AGENDA

PLANNING AND ZONING COMMISSION WORK SESSION MEETING
CITY HALL, 385 SOUTH GOLIAD, ROCKWALL, TEXAS
JULY 28, 2020 IN THE CITY COUNCIL CHAMBERS AT 6:00 PM

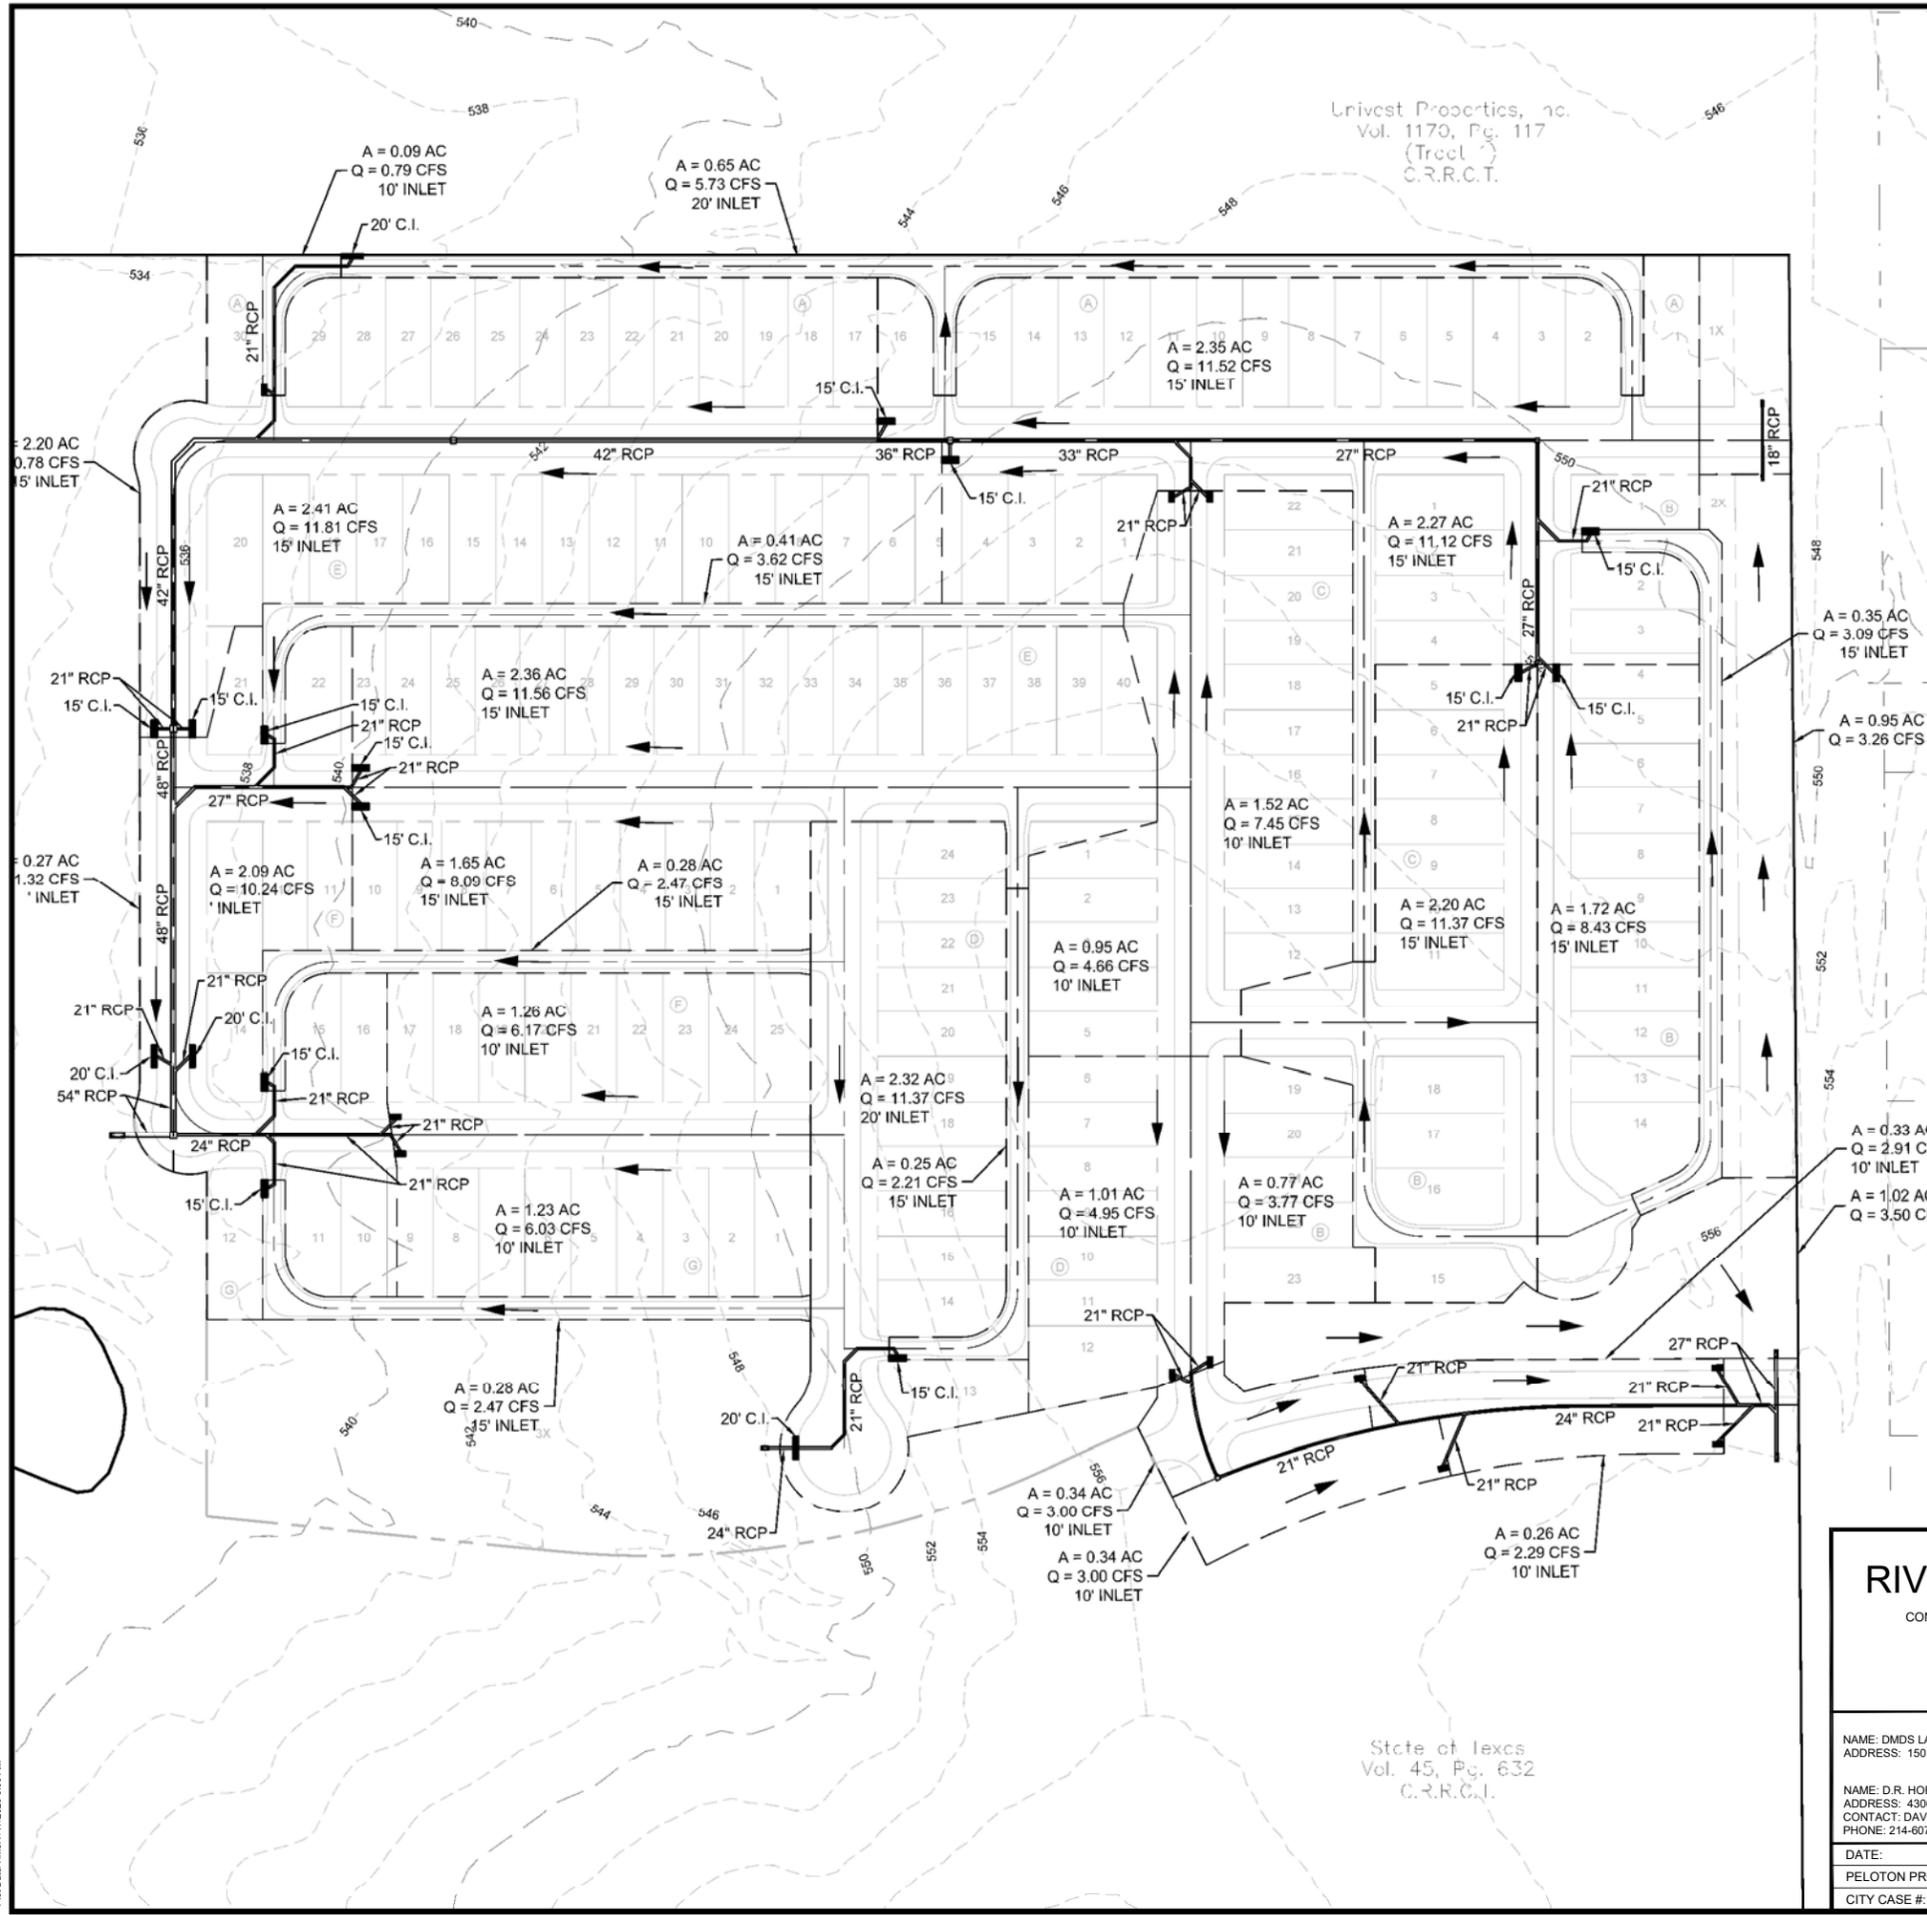
Plan not fully reviewed.
 Site work will need to be reviewed and approved by City Engineering staff.
 Review fees apply.

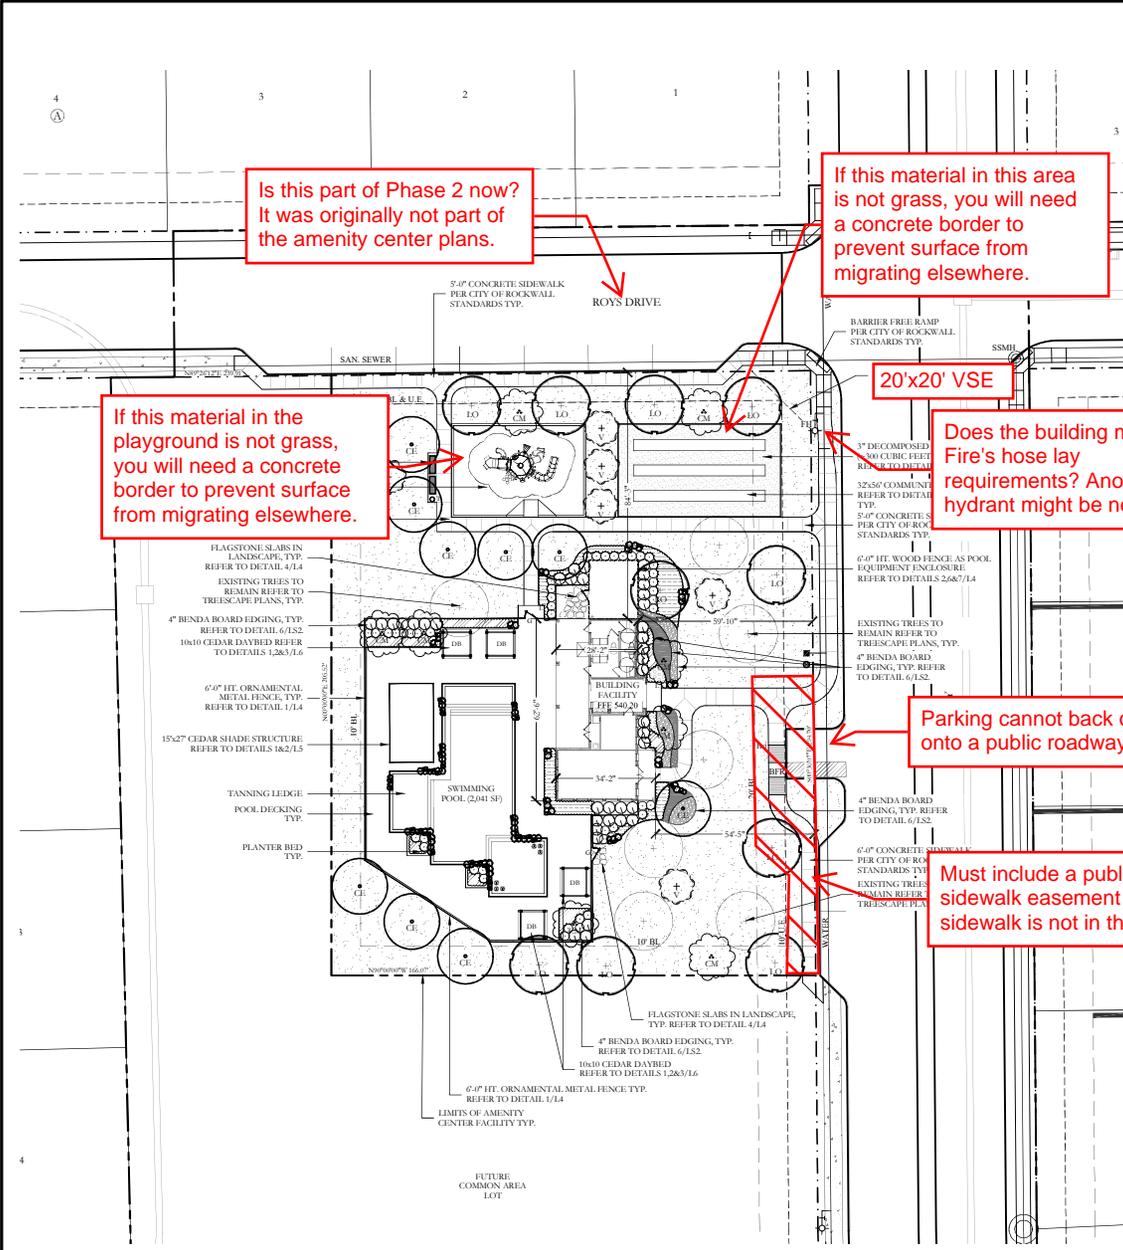
Make sure playground is IPEMA certified

Make sure all trees are 5' from underground utilities

VICINITY MAP

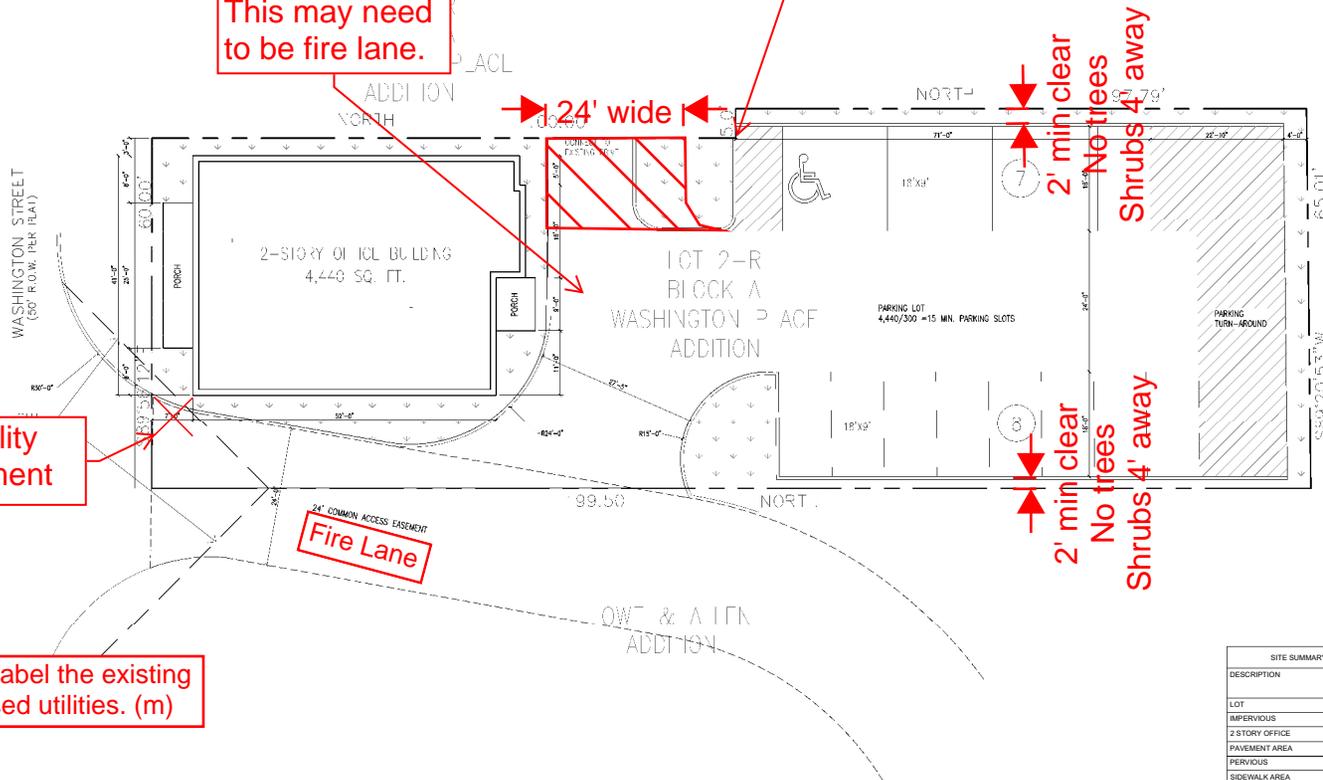
Adequate fire lane coverage? This may need to be fire lane.
